Model type:
TAN2FR

Commercial code:
F035361

51420c0 Exploded views

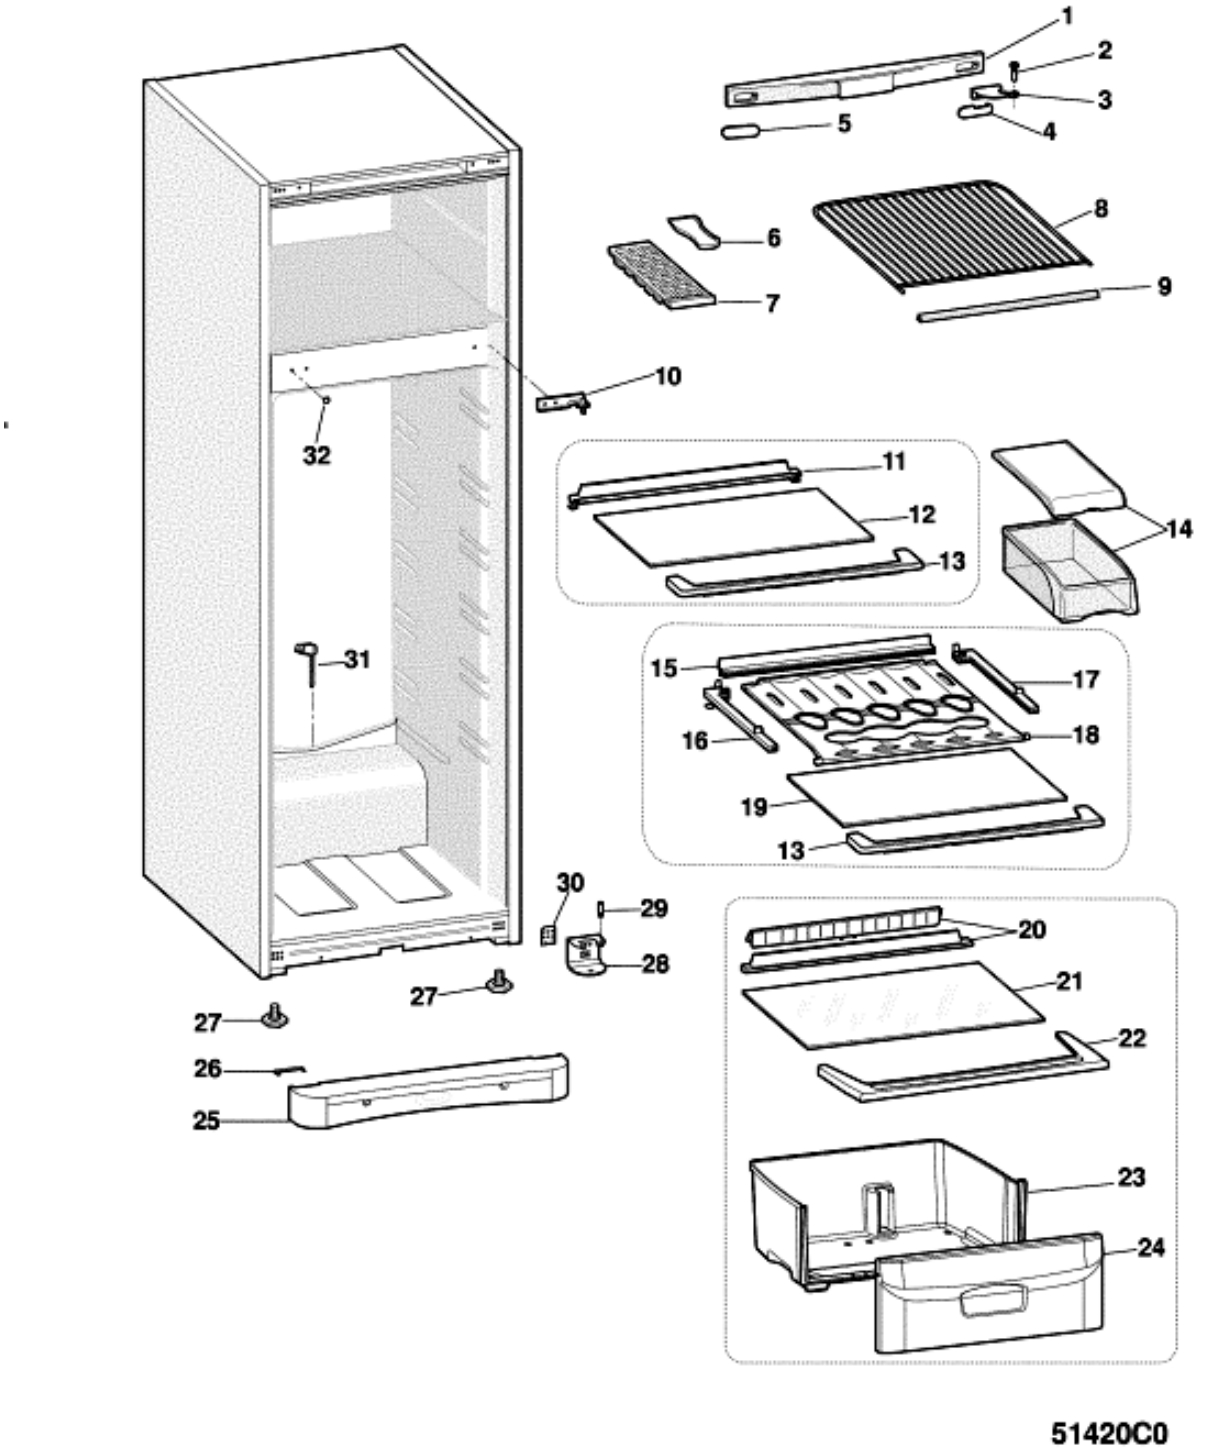
n2510j00: SUBSTITUTION LOWER HINGE PIN

In order to make better the assembly and to prevent an accidental unscrewing of lower hinge pin with consequent falling down of the door, original pin has been substituted by another one longer.

In the course of the time more than one pin has been tested, therefore the history of the substitutions is reported:

C00017658 (13.5mm) --> C00259768 (21mm) --> C00281425 (23mm)

For quality issues on interested models is managed only the last one C00281425 (23mm).

51421m0 Exploded views

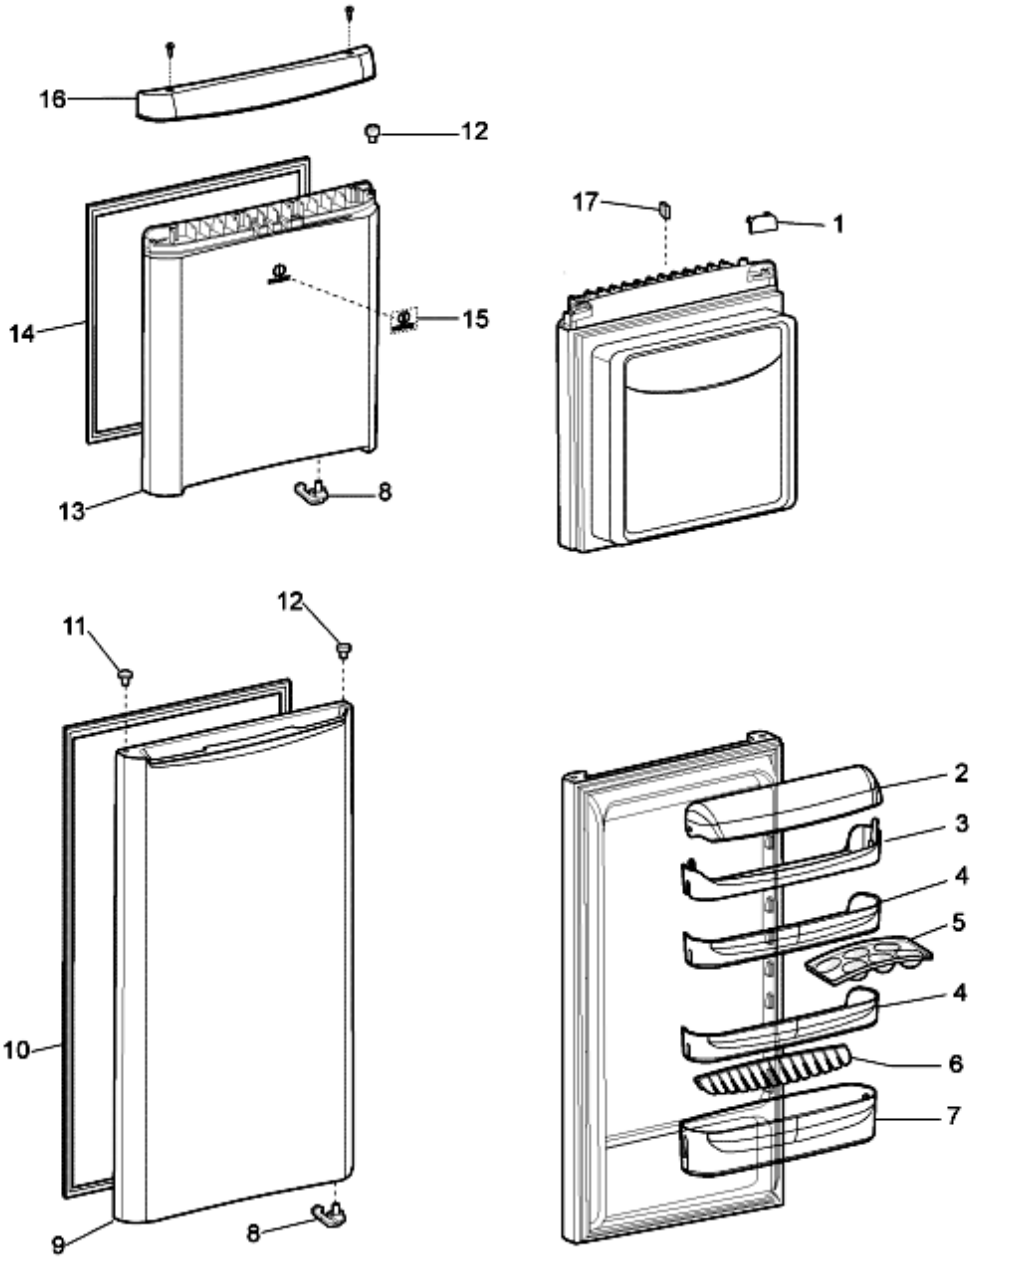
n2511b02: ELIMINATION COVER FOR UPPER DOOR SHELF-INTERNAL ACCESSORIES RESTYLING

Cover for upper door shelf has been eliminated. The upper door shelf has been standardized with the middle one. Subsequently has been standardized with transparent internal accessories instead of those in light blue colour once stock has depleted.

5142260 Exploded views

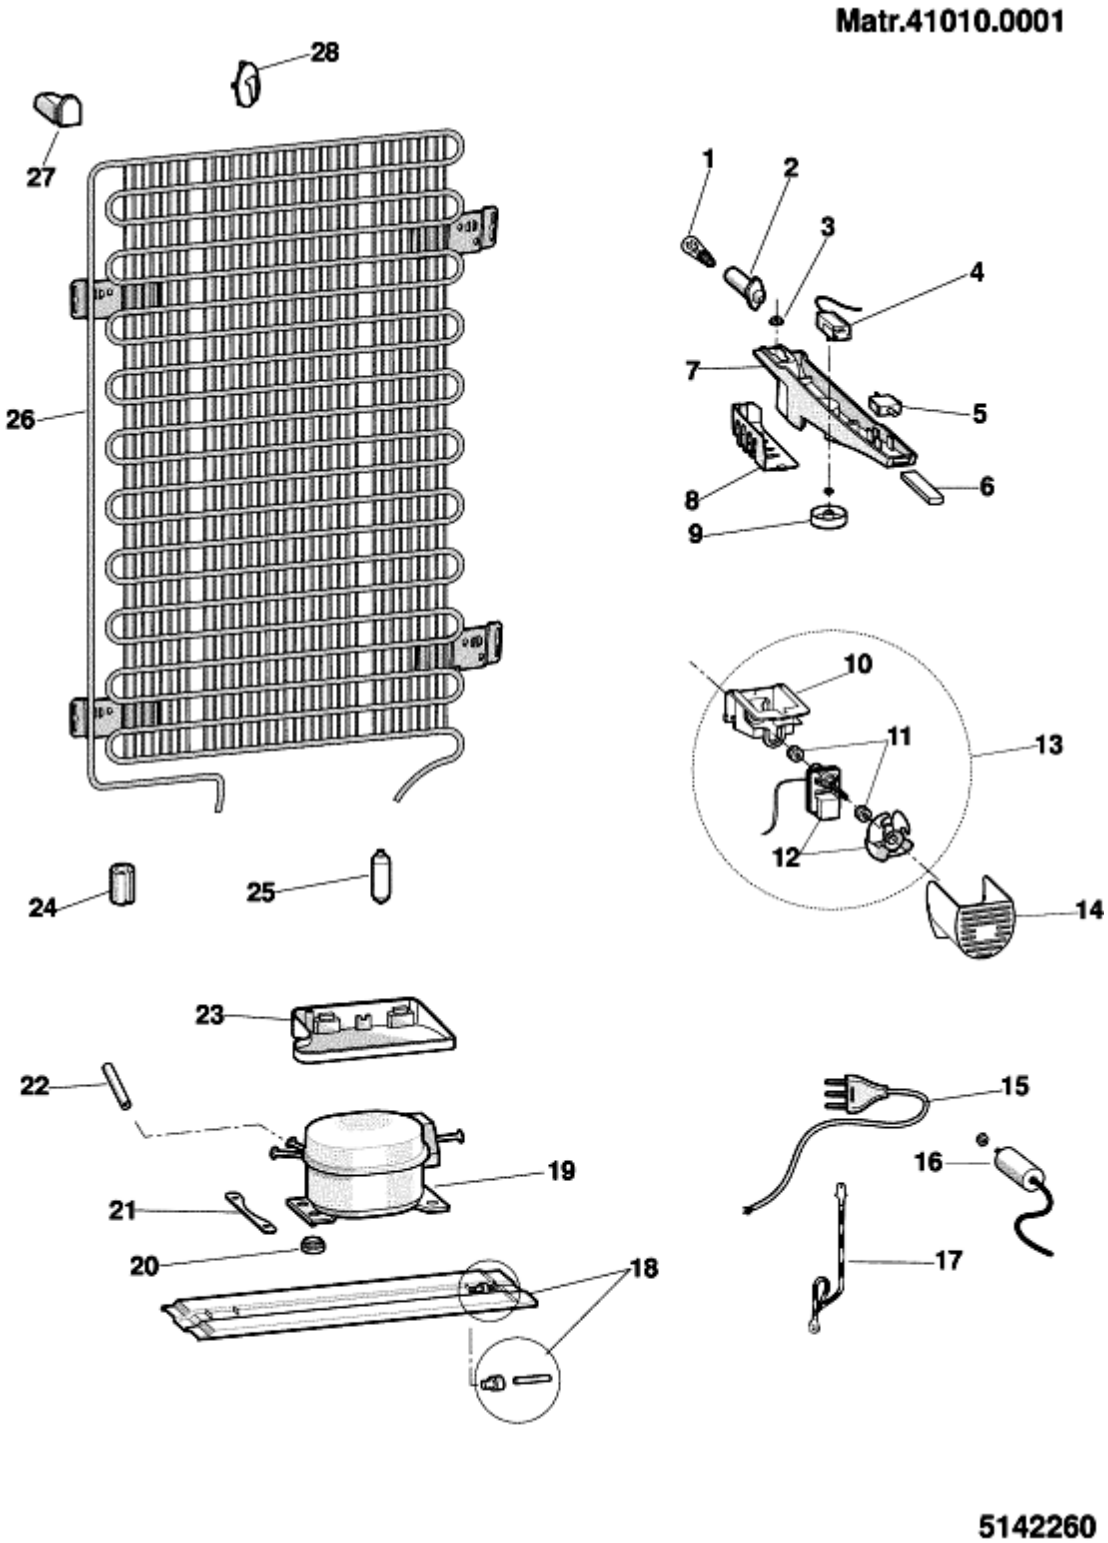
n1025135: Thermostat box on Indesit/Ariston Opera-60 refrigerators (low A.T. +16°C)

As of July 2003, two new "Low ambient temperature thermostat box kits" have been introduced as spare parts for Ariston Opera-60 and Indesit 2000 - 2002 - 2003 range refrigerators with Giugiaro thermostat box (075646).

The kit must only be used to solve freezer performance problems caused by an ambient temperature below +16° C.
This innovative kit features a DIODE, activated by means of the luminous switch, which makes the thermostat box lamp turn on.
It must be activated when the ambient temperature falls below +13°C (closed contacts: see the wiring diagram that comes with the kit).
The heat produced by the lamp activates the thermostat, thus ensuring regular operation of the appliance.
When replacing the thermostat box, no component can be reused (including the wiring).
The kit wiring has pin terminals for connection to the terminal block on the compressor; some modifications may be required for other solutions.
Given below is the list of kit items available as spare parts:
